CORRIGENDUM / ADDENDUM TO TENDER DOCUMENT-

OFFICE PREMISES VARANASI DATED 10/04/2019

Modification in Tender Documents already hosted by SIDBI in respect of seeking invitation of offers for acquiring office premises on Leave and License basis at Varanasi, UP

Appendix -ii

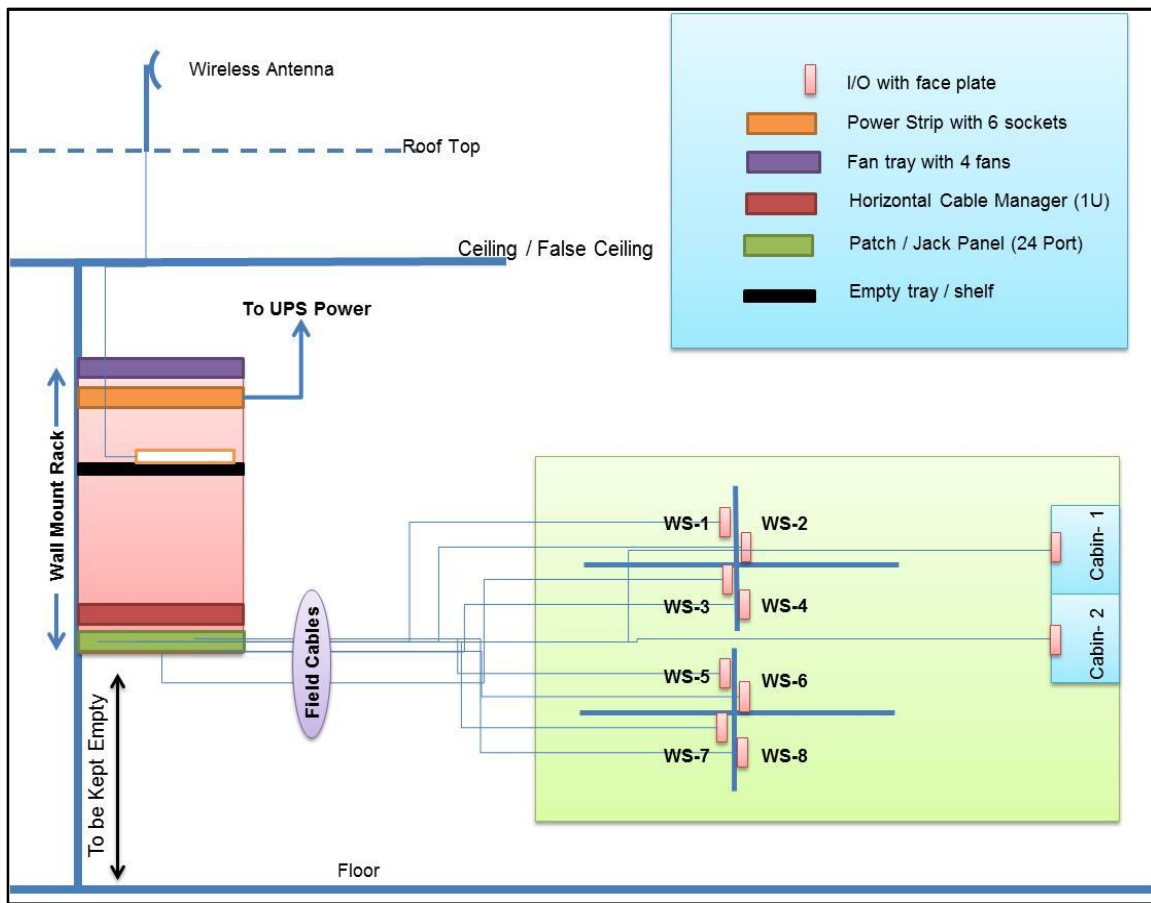
Sr No	As per tender Document hosted	Revised																											
<p>Page No. 32 (sr. No. 17)</p>	<p>LAN Cabling -From UPS / Switch room to all the workstations / seats LAN cabling with CAT - 6 approved make cable to be provided in PVC conduit alongwith suitable modular type outlet boxes and RJ-45 connectors</p>	<p>LAN Cabling – The LAN cabling to be provided should be structured with the following components installed:</p> <p><u>a). Network Rack (Metal)</u> <u>(i) Specifications / Requirements of Rack and Patch cords</u></p>

9	Horizontal Cable Manager of size 1U	One
		10	Factory Crimped 7 feet CAT 6 patch cord	15
		11	Factory Crimped 3 feet CAT 6 patch cord	15
		<p>(ii). The rack would be installed at a location where there is air conditioning. In case of floor mounting rack, the space above the rack till the ceiling / false ceiling should be kept open for future requirements / expansions and in case of wall mount rack, the space below the rack should be kept open for future requirements / expansions.</p> <p><u>(b). Cabling</u></p> <p>(i). Surface mount Information Outlet (I/O) boxes with connectors affixed to the partition along with face plate one each at each workstation/ cubical/ cabin/ conference room and for printers.</p> <p>(ii). All field cables originating from workstation / cubical/cabin/conference room/printer should be terminated / crimped to the patch / jack panels. Numbering of cables at both ends and on patch/jack panel to be carried out.</p> <p>(iii). All field cables within the bank premises should be laid through PVC conduit along a duct.</p> <p>(iv). All ports on patch panel, I/O and cables should be properly tagged for easy identification. Complete LAN diagram to be provided.</p> <p>(v). All cables and passive components (I/O, patch/jack panel etc for LAN connectivity should be CAT 6 only.</p>

(vi). Total Number of Network Points - 15 c). For illustration purpose structured cabling diagram is given in Appendix -ii.
--	--	---

1. The diagrams are for illustration purpose only.
2. The size of rack, number of - patch/jack panels, Horizontal cable manager, empty shelves/trays etc. are as per RfP specifications.
3. **Wall Mount Rack**
